RE: Federal Cell Facility Application Request for Information

Federal Cell Application Review

Request for Information or Updates to the Application (RFI)

Appendix B: Federal Cell Facility Engineering Drawings

CLIVE FACILITY
FEDERAL WASTE CELL
DISPOSAL CELL BUFFER ZONE
CLIVE, UTAH

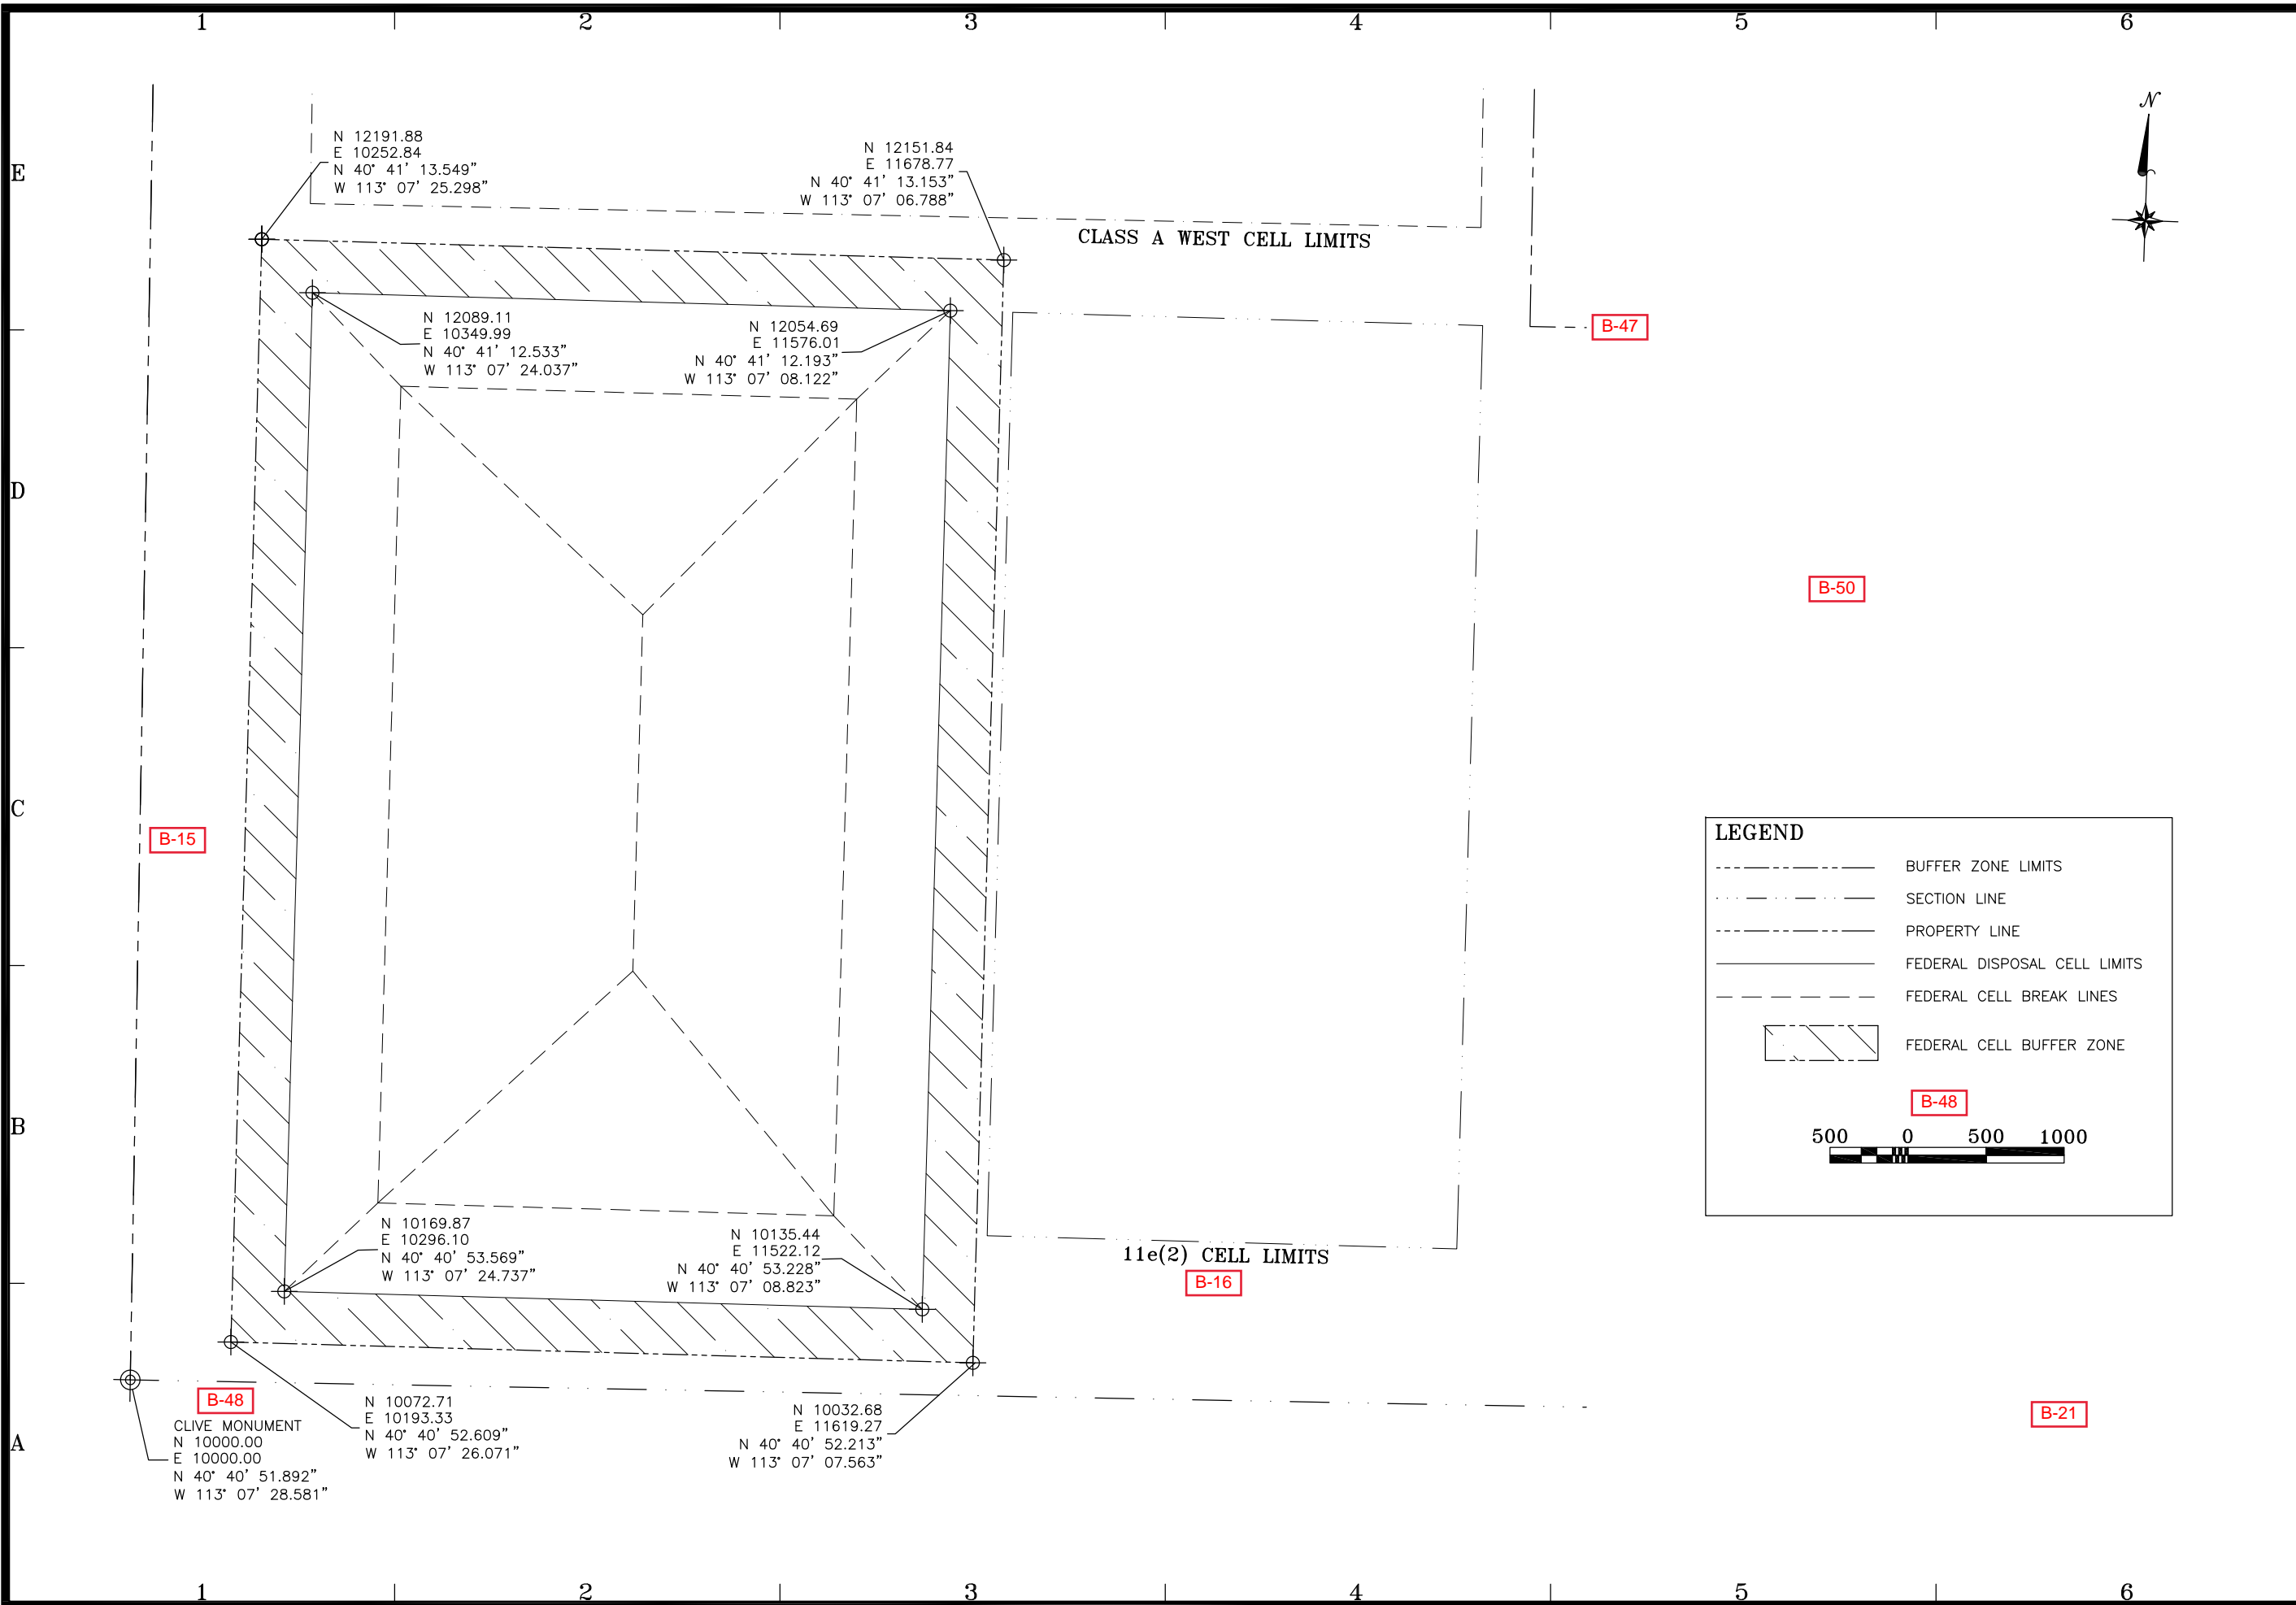
- **B-48**

- **B-50**

CLIVE FACILITY
FEDERAL WASTE CELL
DISPOSAL CELL WASTE LIMITS--LATITUDES & LONGITUDES
CLIVE, UTAH

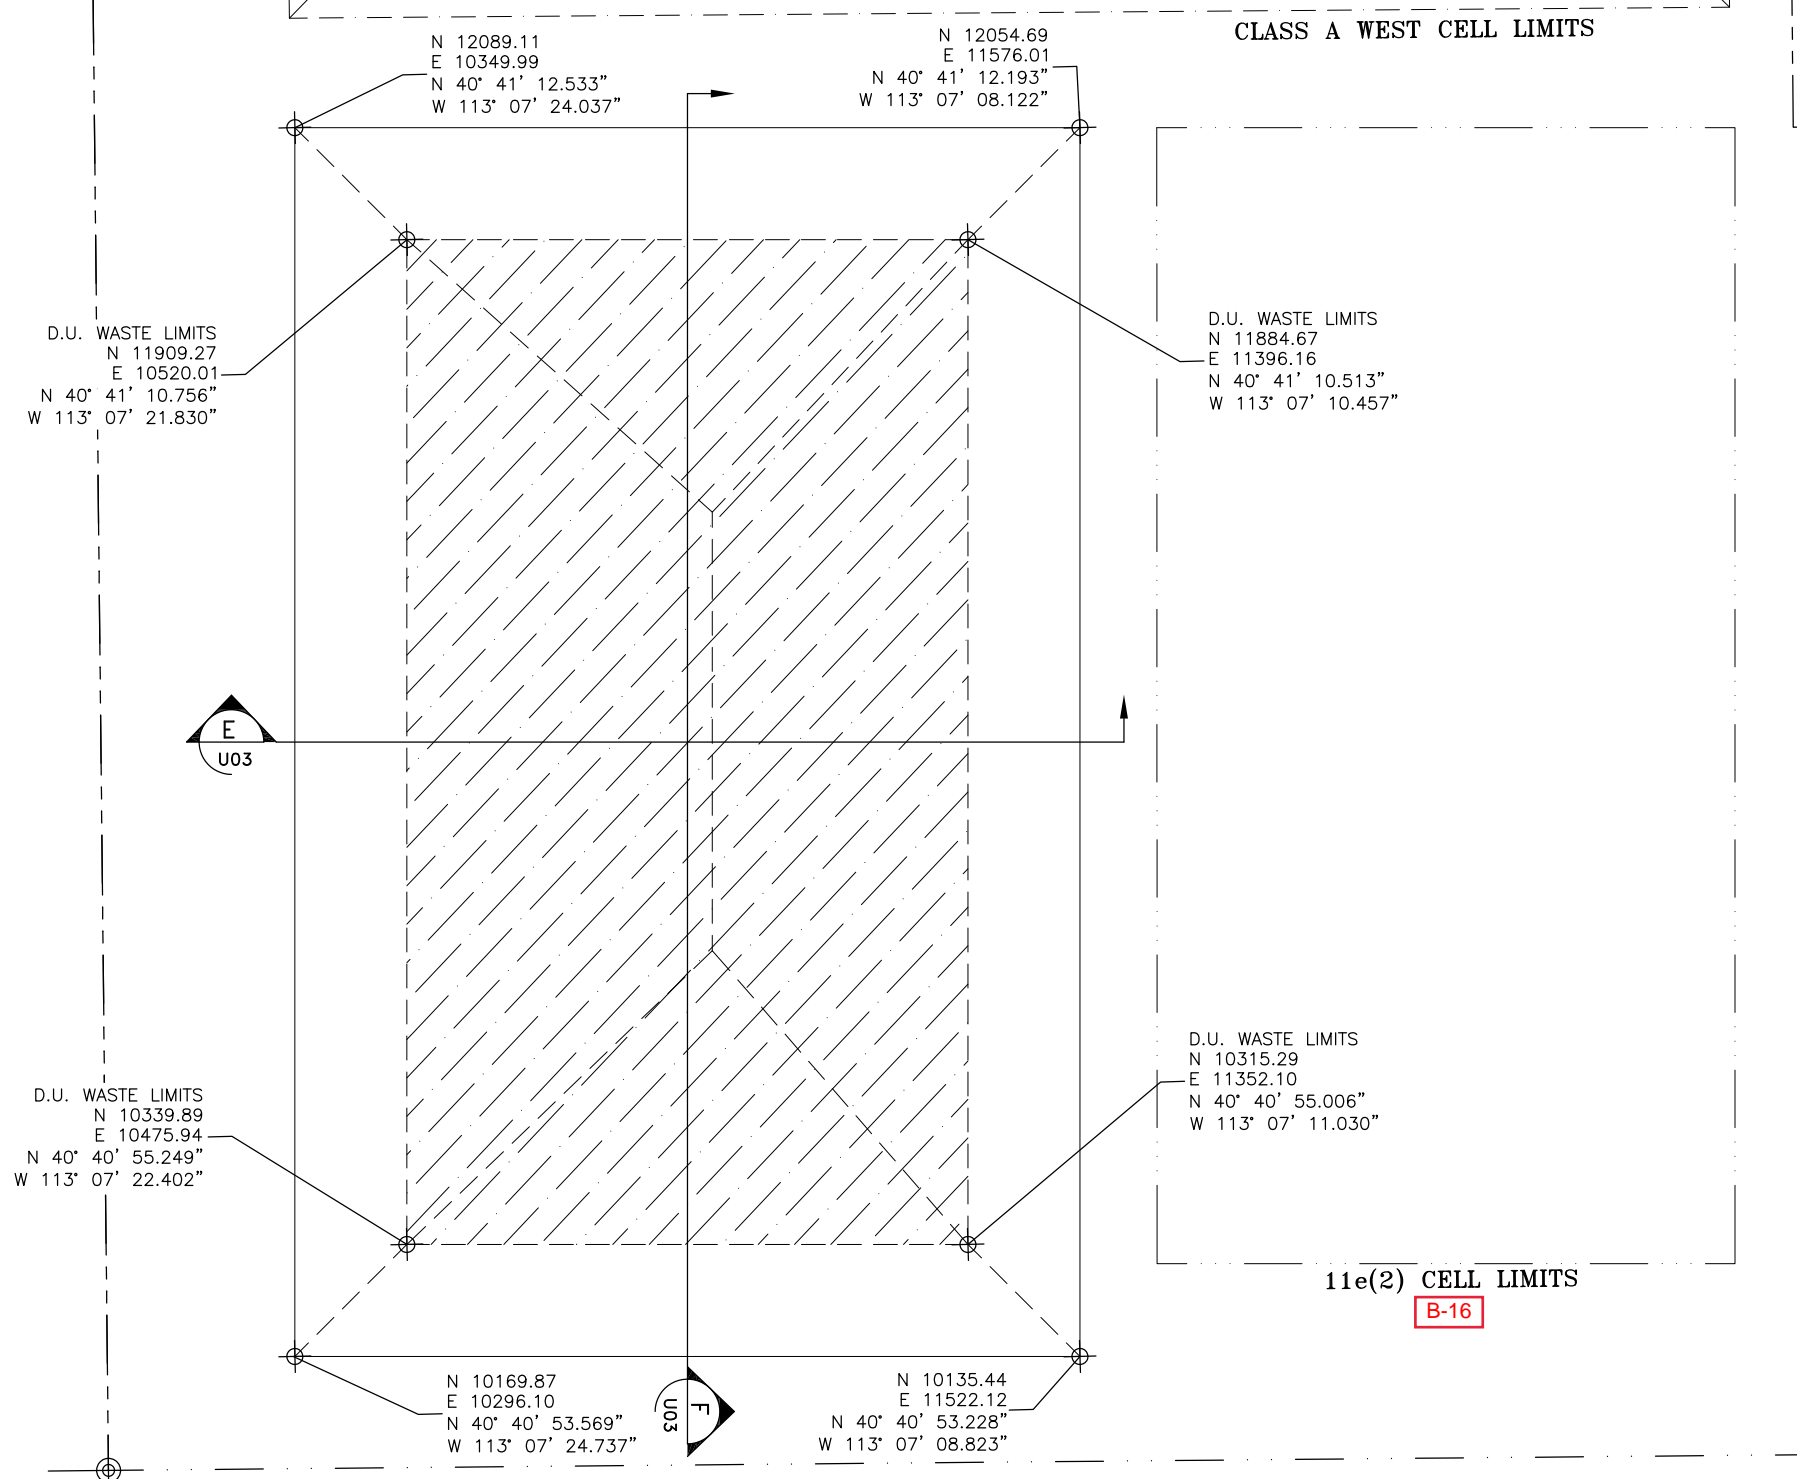
- **B-47**

- **B-49**

E WEST-EAST CROSS SECTION
 U02 HORIZONTAL SCALE: 1" = 200'
 VERTICAL SCALE: 1" = 20'

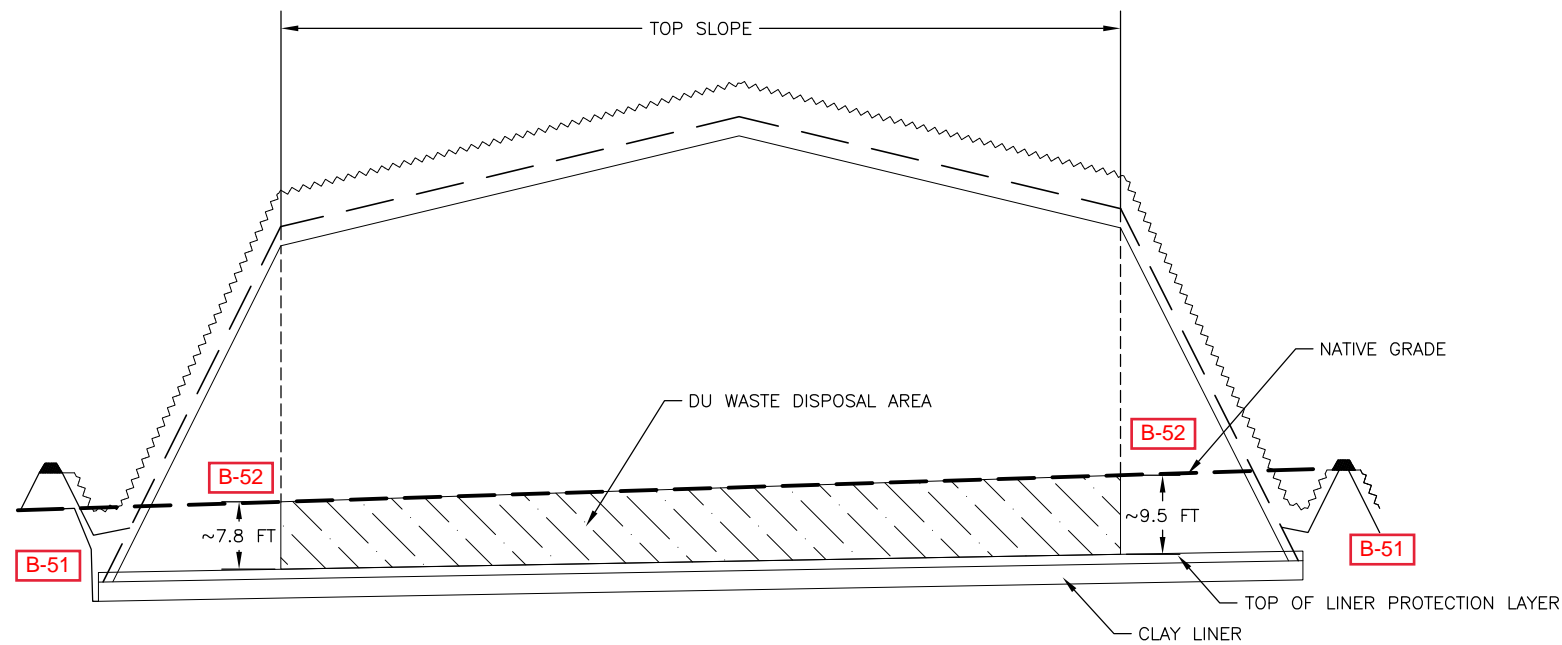
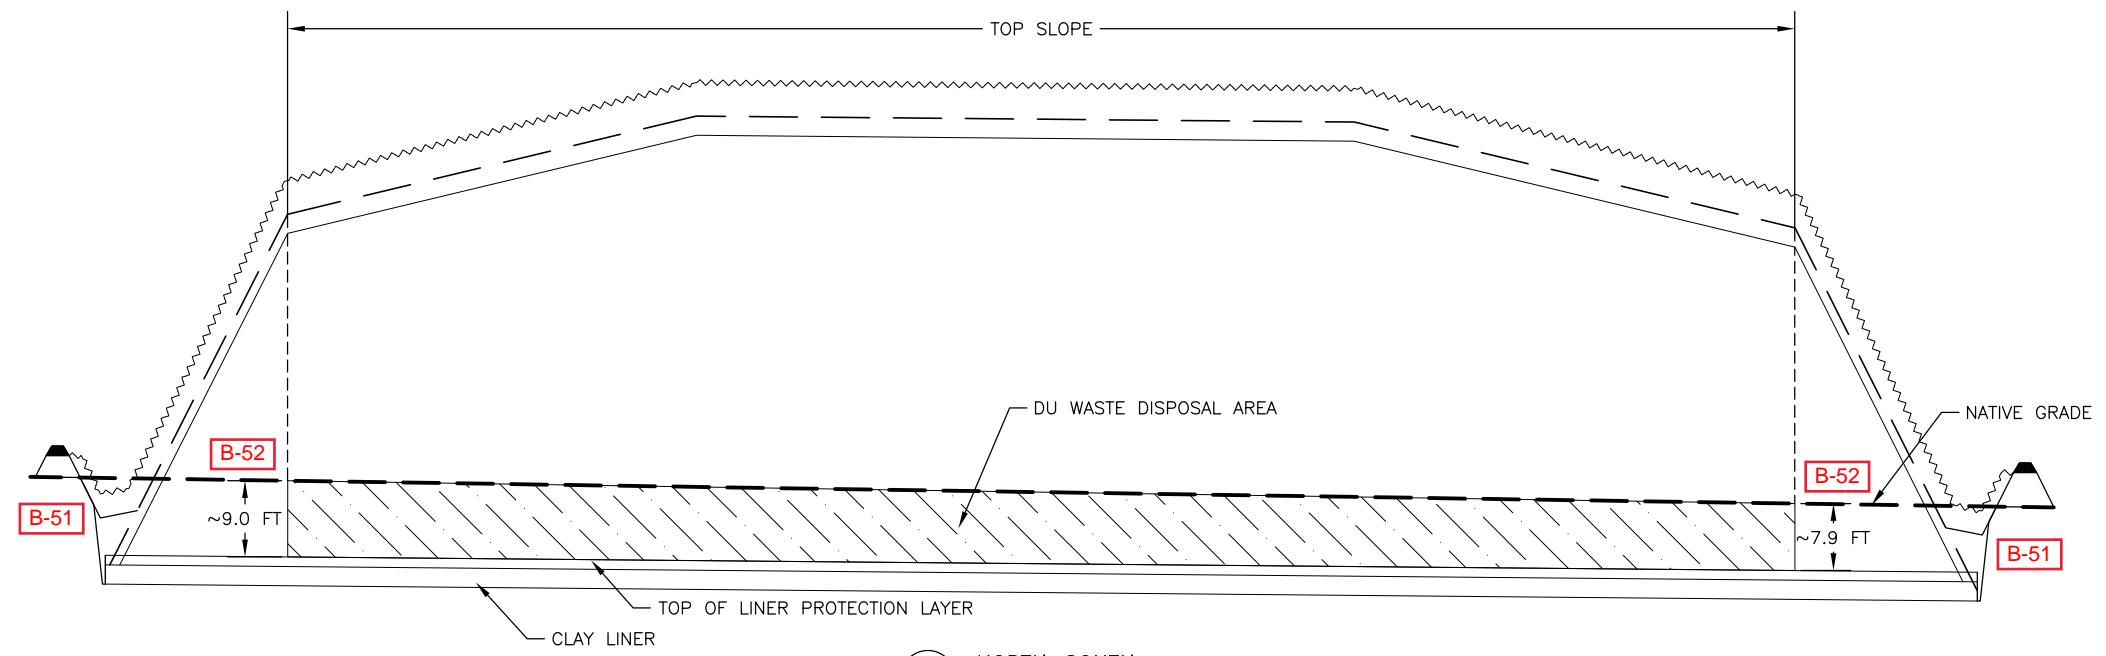
- **B-51**

- **B-52**
